**Record of Decision  
Operable Units 2 & 4**

**Greenwood Chemical Superfund Site  
Newtown, Albemarle County, Virginia**

**September 2005**

RESPONSIVENESS SUMMARY  
FOR THE PROPOSED REMEDIAL ACTION PLAN  
FOR THE GREENWOOD CHEMICAL SUPERFUND SITE  
OPERABLE UNITS TWO & FOUR

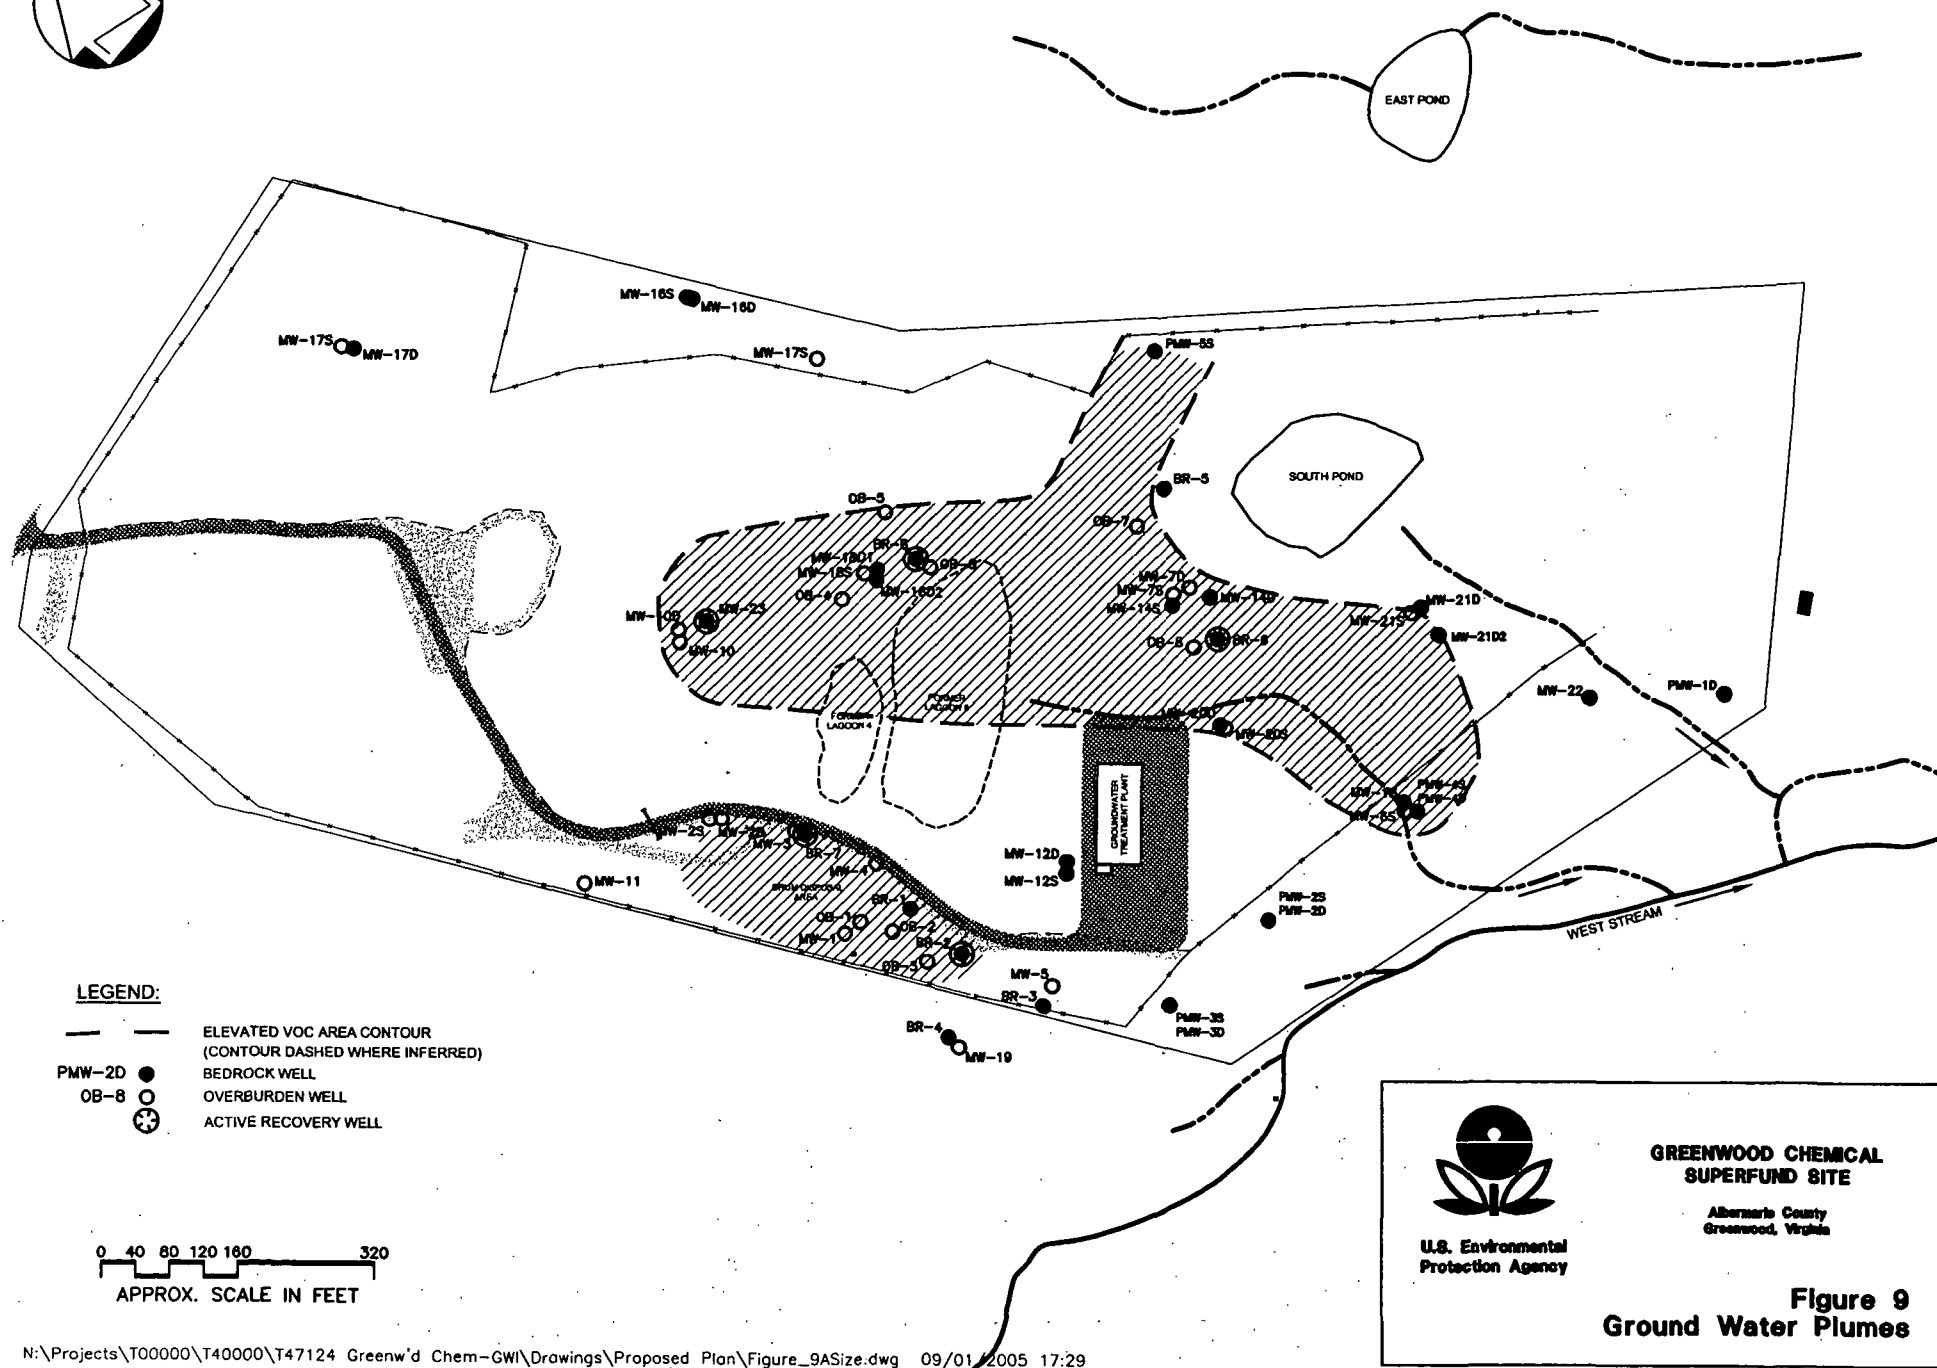
4. Citizens noted that information EPA presented several years ago did not indicate that the ground water contaminant plume was leaving the Site. A citizen referred to the current map (see Figure 9 in the ROD) showing an "arm" of the ground water plume branching to the east and migrating beyond the property boundary. The citizen asked why EPA did not know the plume was migrating off the site before and whether EPA knows the extent of the plume now.

**EPA Response:** While it is possible that some part of the contaminant plume is migrating offsite, EPA believes that the selected remedy will capture it, and in any event will prevent it from spreading any further. The Ground Water Investigation and Focused Feasibility Study which EPA completed in June 2005 was designed to fill in any existing data gaps with respect to EPA's understanding of ground water at the Site, and to develop a final ground water cleanup decision. The primary objective of the investigation was to comprehensively determine if the existing recovery wells were containing the contaminated ground water on Site and, as appropriate, to identify additional ground water recovery well locations which may be necessary to achieve containment.

EPA determined that additional monitoring wells were necessary along the perimeter of the Site to fill in existing data gaps. Of relevance to this comment, EPA focused on a small gully located on the eastern side of the property. Recognizing that ground water generally flows downhill, in the same direction as surficial topography, in 2004 EPA placed ground water monitoring well PMW-5 at that precise location to determine if this gully might create localized ground water flow to the east.
